CHANGE NOTIFICATION

PCN# 011314

Subject: Notification of Assembly Process Change for LTM8042/LTM8042-1

LTM8042/-1 - Current and New Design

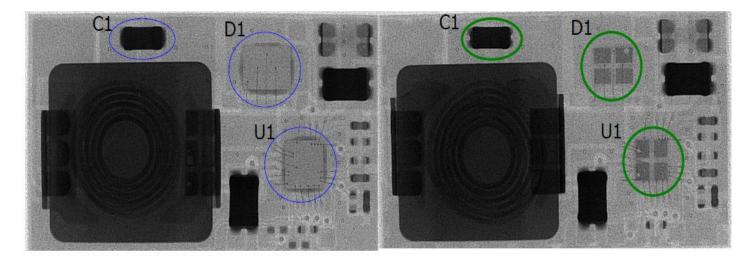
Please be advised that Linear Technology Corporation has made a minor change to the internal package construction to facilitate the use of one attach material for both die and components. The die attach material is changed from epoxy to solder, which is already used for attaching components in the same μ Module device package. In order to use the solder die attach, the die attach paddle (DAP) has been modified by splitting the DAP into multiple pads for dice D1 and U1. Additionally, the attach pad for component C1 has also been split into multiple pads. Linear has been shipping several μ Module devices using solder for die attach and component attach.

BEFORE: EPOXY + STD DAP

AFTER CHANGE: SOLDER + WP DAP
